The Flyers Creek VIA for turbines now proposed in Modification 4

The above image is a section of wireframe Fig 20 showing the nearest turbines to residence 89, the closest turbine being 1144 metres from the dwelling.

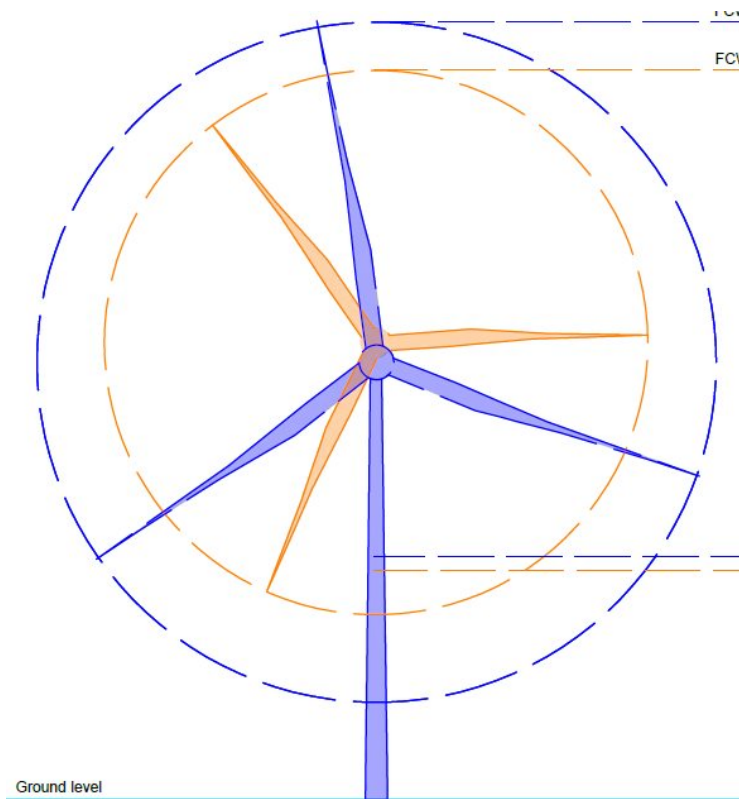
This is **not** a wireframe designed to show how many turbines may be visible from the residence.

This is **not** a wireframe designed to show the layout of the wind farm from this viewpoint.

This is a wireframe designed specifically to show the visual difference between the approved turbines and the proposed turbines from that viewpoint.

So, these two images are designed to show the same thing. Never have I seen a wireframe or photomontage so divorced from reality and so misleading and I dare say, neither has anyone in the Department.

If Mr Homewood thinks I've got it wrong, I invite him to publish his version of those two images to scale.
